October 24, 2012

RE: Draft Comprehensive Wastewater Management Plan and Draft Environmental Impact Report, and Notice of Project Change: Little Pond, Great Pond, Green Pond, Bourne Pond, Eel Pond, and Waquoit Bay Watersheds and Recommendations for West Falmouth Harbor Watershed

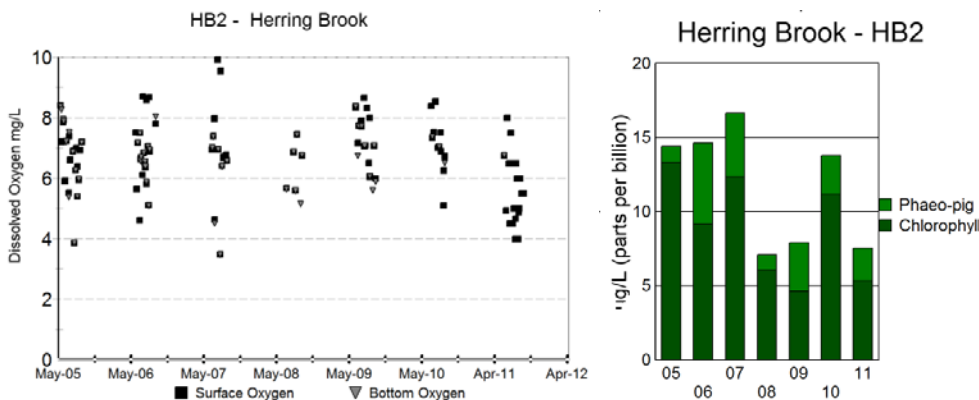
In a letter dated December 19, 2011, the Coalition provided comments to the Town of Falmouth on the GHD Technical Memorandum No. 9 (Tech Memo 9), which considers the feasibility of Sites 7 and 10 as wastewater recharge sites. The Coalition would like to re-affirm the concerns stated in that letter – that the water quality impacts on receiving waters of discharged effluent from Sites 7 and 10 have not been adequately characterized.

Tech Memo 9 asserts that effluent recharged at Site 7 will discharge into Herring Brook and Buzzards Bay at Herring Brook and between Herring Brook and West Falmouth Harbor. Effluent recharged at Site 10 will discharge to Wing Pond, West Falmouth Harbor, and Buzzards Bay at Herring Brook and beyond West Falmouth Harbor (Tech Memo 9). Each of these water bodies is sensitive to nutrient inputs. **This DCWMP/DEIR will not be a victory for the Town of Falmouth or the environment if water quality improvements in South Coast Ponds are achieved at the cost of water quality degradation in other water bodies.**

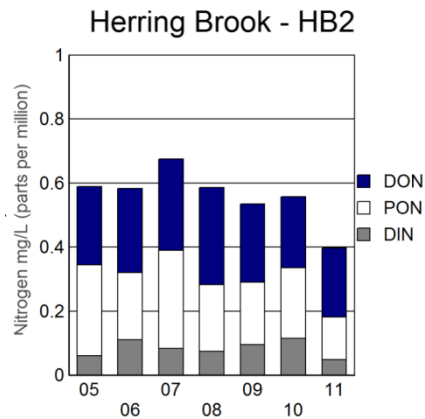
In the absence of an MEP report for Herring Brook to determine what an appropriate concentration of total nitrogen is, we look to similarly situated estuarine habitats for guidance. The Massachusetts Estuaries Project calculated a threshold nitrogen concentration for Mashapaquit Creek in West Falmouth Harbor at 0.412 mg/L. *Massachusetts Estuaries Project Linked Watershed-Embayment Model to Determine Critical Nitrogen Loading Thresholds for West Falmouth Harbor, Falmouth, Massachusetts* page 136.

Coalition data illustrate nitrogen concentrations at the mouth of Herring Brook which exceed those concentrations found by the MEP to be protective of water quality in neighboring salt marsh environments indicating an impaired water body unable to assimilate any new source of nitrogen. Importing a new nitrogen load from outside the Herring Brook watershed is inappropriate and would contribute to a violation of state water quality standards.

CBB1 - Buoy

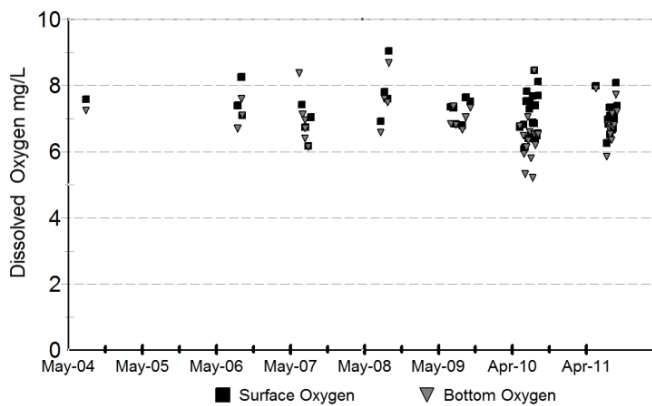
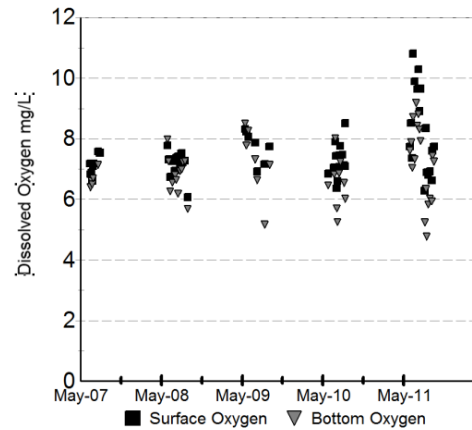
As stated above, class SA waters shall not have a dissolved oxygen level below 6 mg/L, shall have excellent aesthetic value and shall be free from color and turbidity in concentrations that are aesthetically objectionable or would impair the resource. *314 CMR 4.05(4)(a)*. However, dissolved oxygen in central Buzzards Bay is beginning to reach levels below 6mg/L.
